Current MIC board assembly

Modified MIC test

Change list:

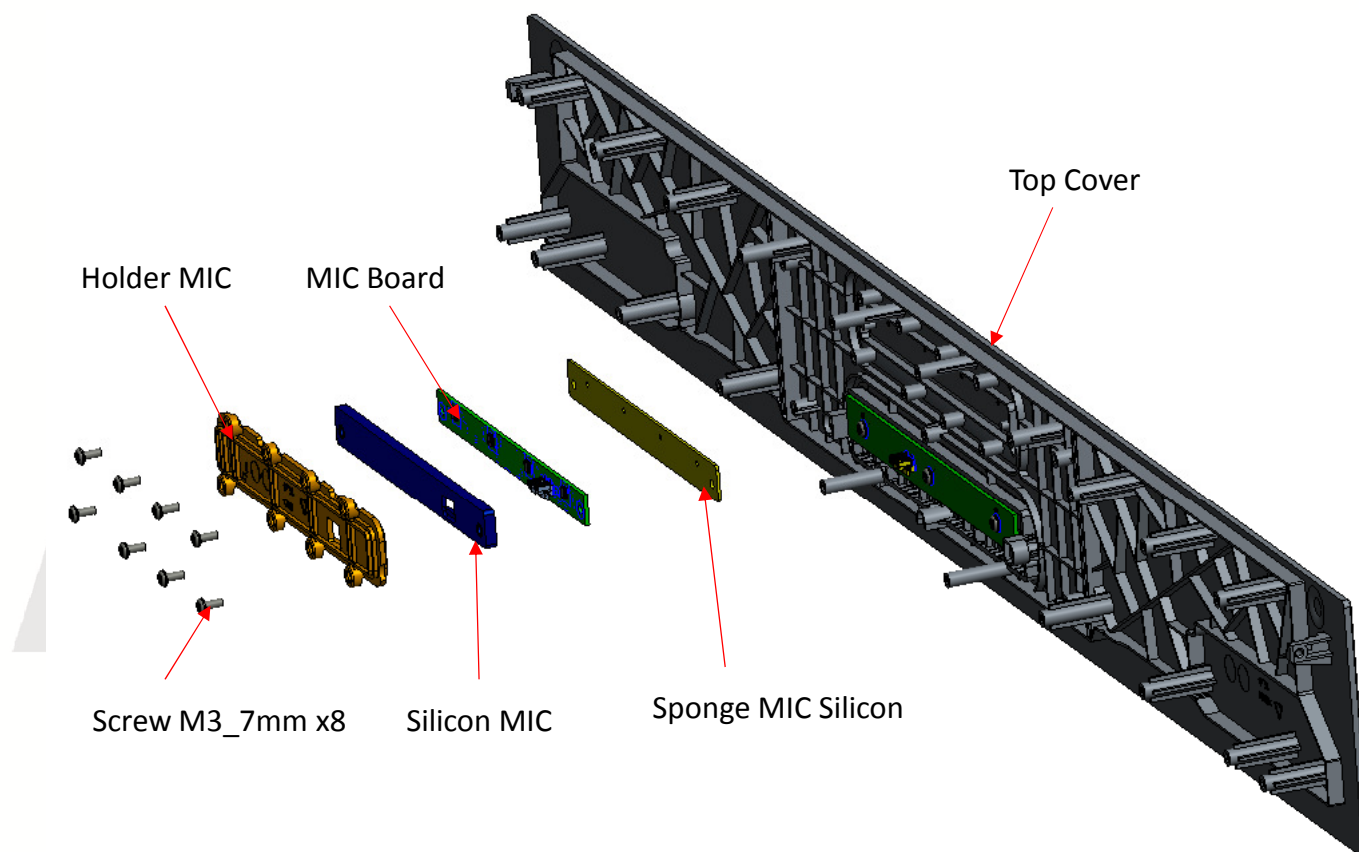
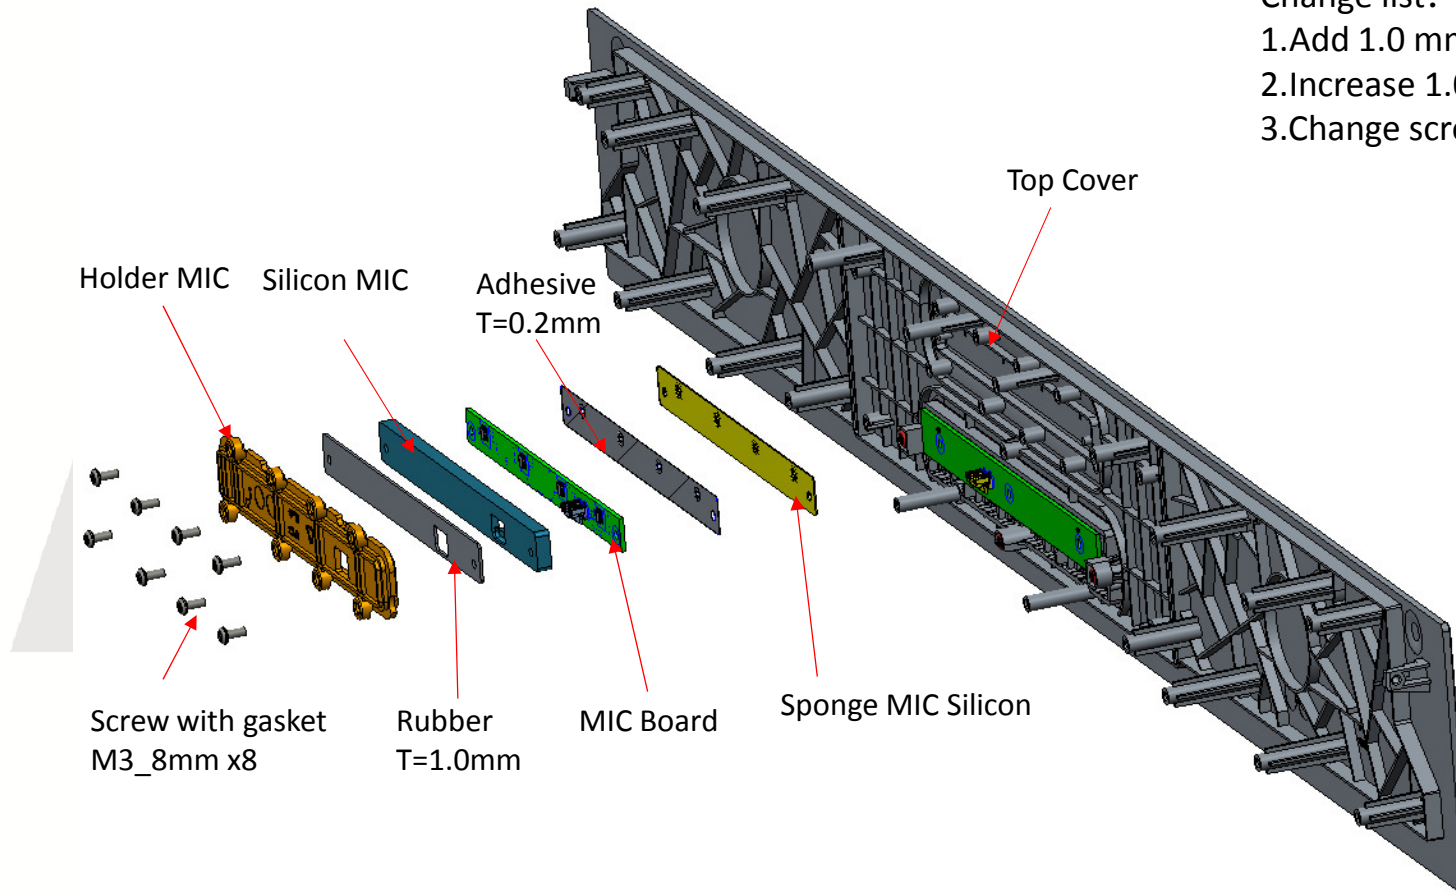
- 1.Add 1.0 mm thickness adhesive on PONGE_MIC_SILICON
- 2.Increase 1.0mm thickness in SILICON_MIC
- 3.Change screw M3*7 to M3*8(with gasket)

SPONGE_MIC_SILICON

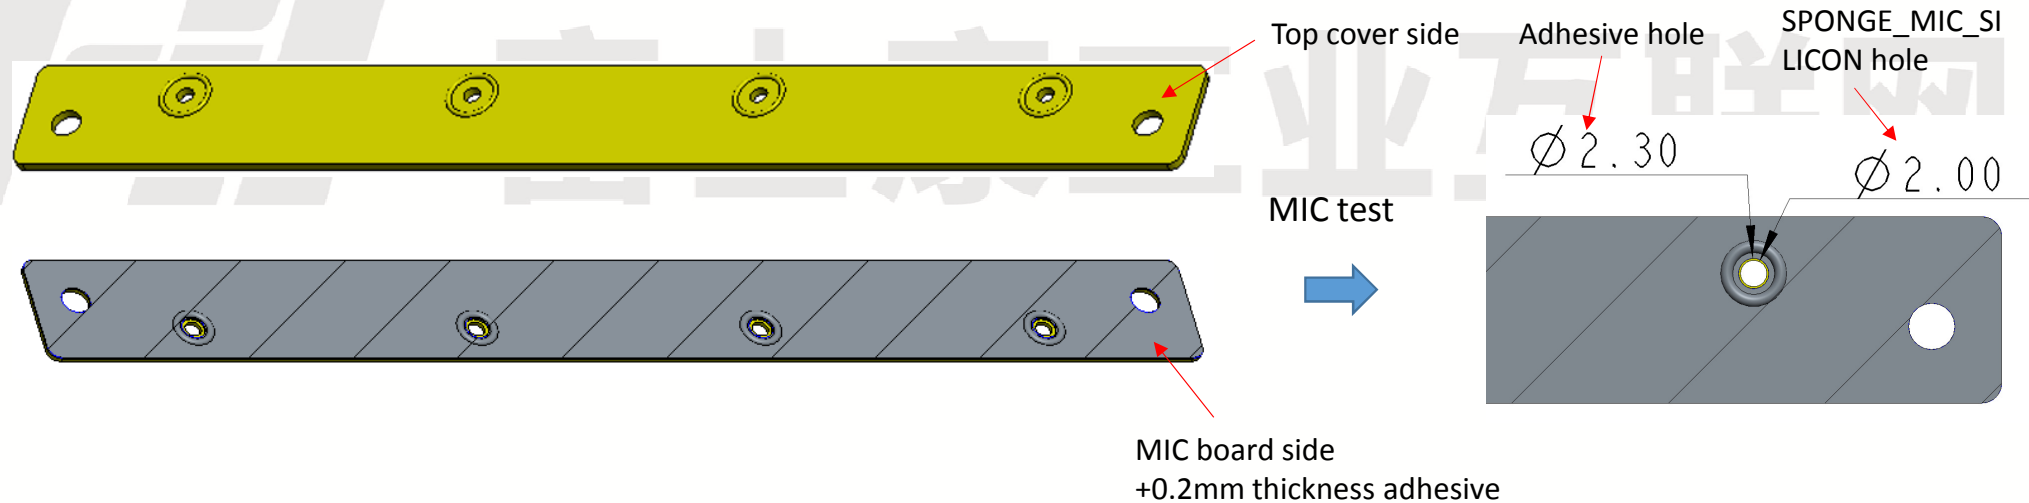
Add 0.2mm thickness adhesive on the MIC board side

SILICON_MIC

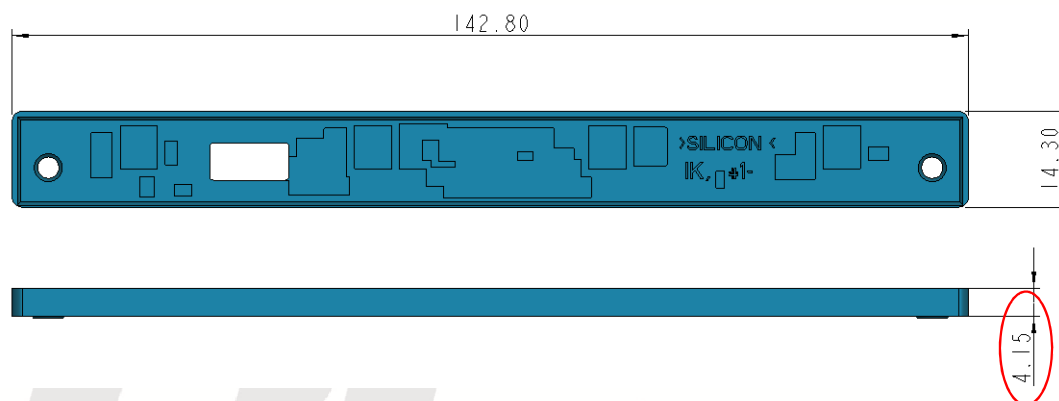
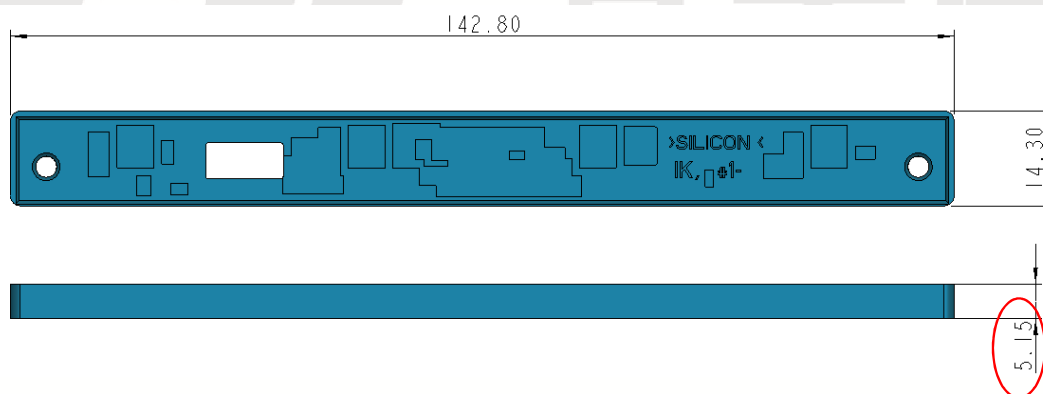
Suggest to modify in next build

Increase 1.0mm thickness in SILICON_MIC

SCREW

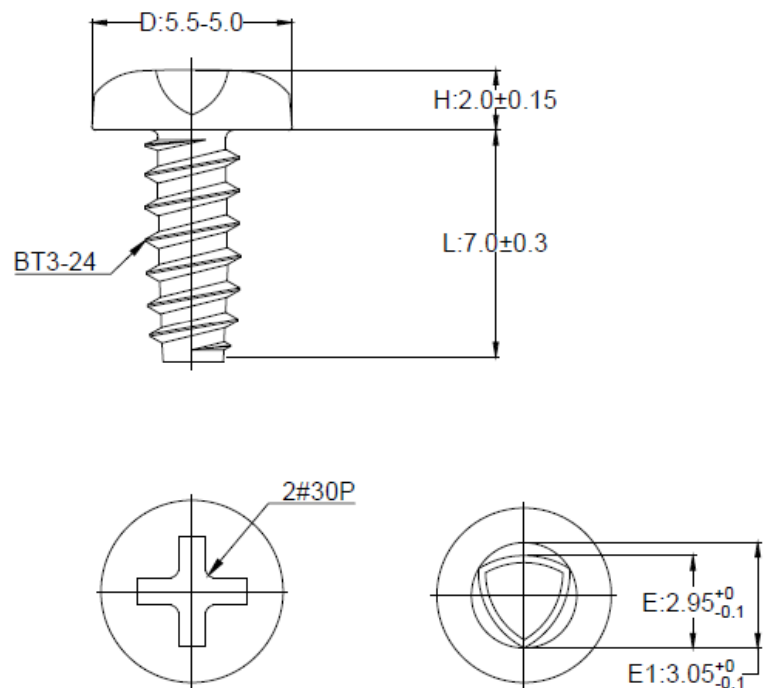
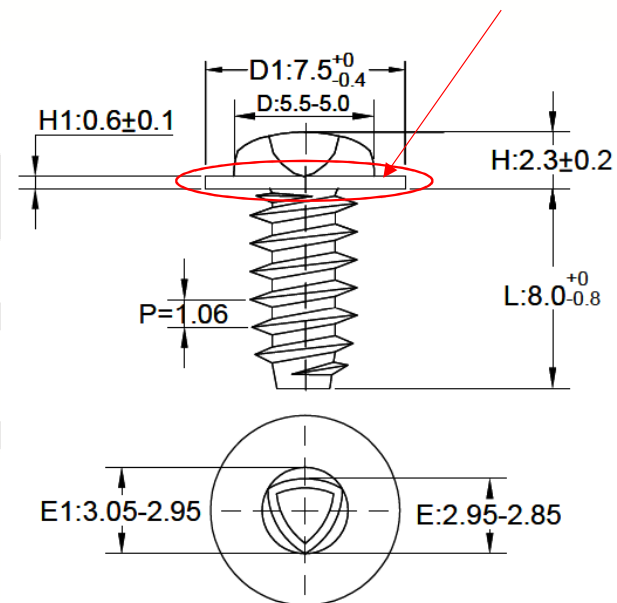
Modified screw

Screw with gasket
